**ADDENDUM NO. 1**  
**To Contract Documents**  
**For**  
**Vinland Elementary School Gravity Sewer**  
**Page 1 of 2      Issued: June 21, 2018**

**Item:** 1  
**Sheets:** C2, C3, and D2  
**Description:** Add these new sheets to the Construction Plans. Revisions include the addition of concrete pipe encasement, manhole inserts, ADA cross slope requirements for concrete sidewalk and asphalt path, and 8" CSTC for trench repair.

DRAWING NO.  
6 OF 8  
C3

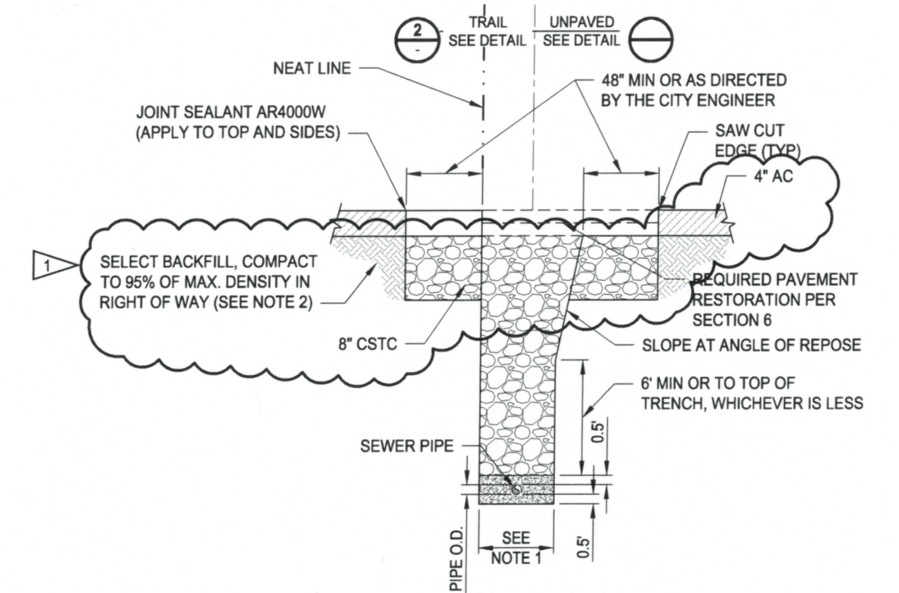
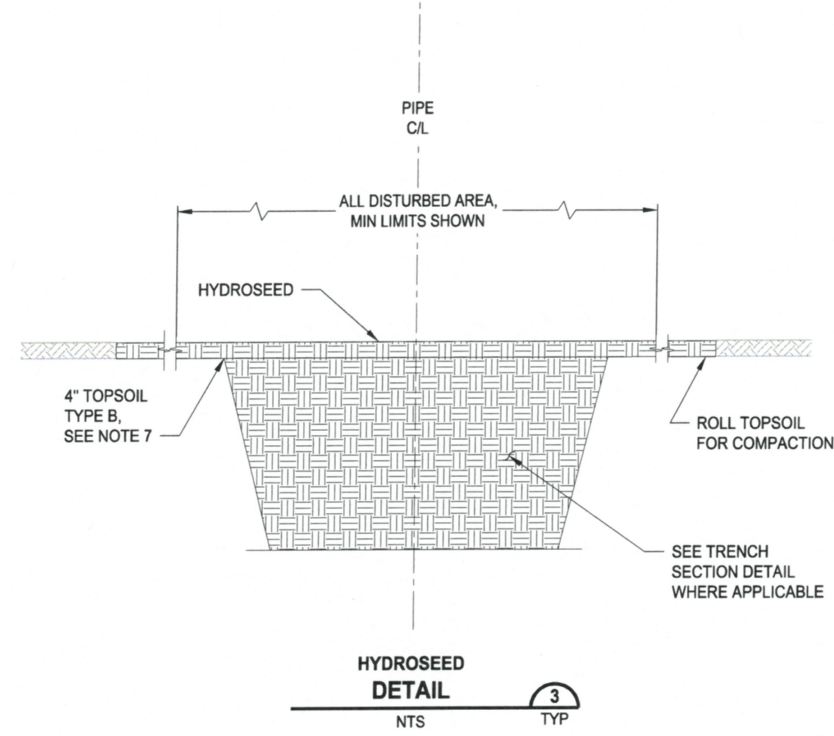
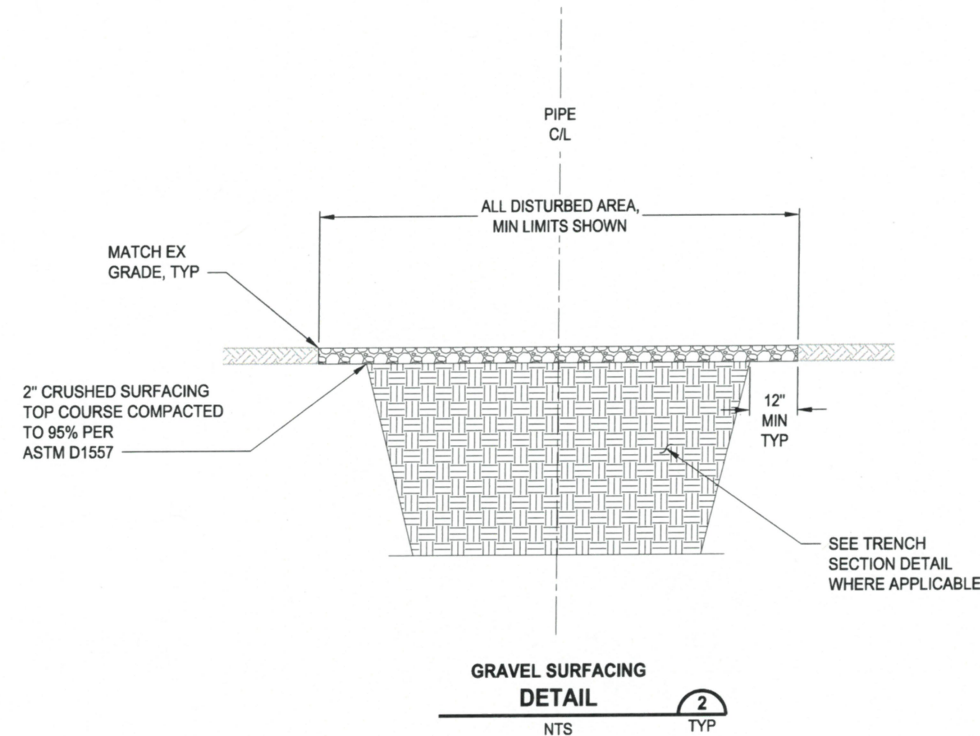
- 1 REMOVE AND REINSTALL FENCE AS NEEDED
- 2 REMOVE AND REINSTALL EXISTING SWING SET AND CURBING
- 3 DEMOLISH AND REINSTALL EXISTING SIDEWALK AND GUTTER, SEE COP DETAIL 2-22 SHEET D1
- 4 PROTECT EXISTING LIGHT POLE.
- 5 PROTECT EXISTING CATCH BASIN IN PLACE
- 6 PROVIDE TEMPORARY TRAFFIC CONTROL PLAN
- 7 REPLACED SIDEWALK SHALL MEET ADA REQUIREMENTS WITH A MINIMUM 1.5% CROSS SLOPE
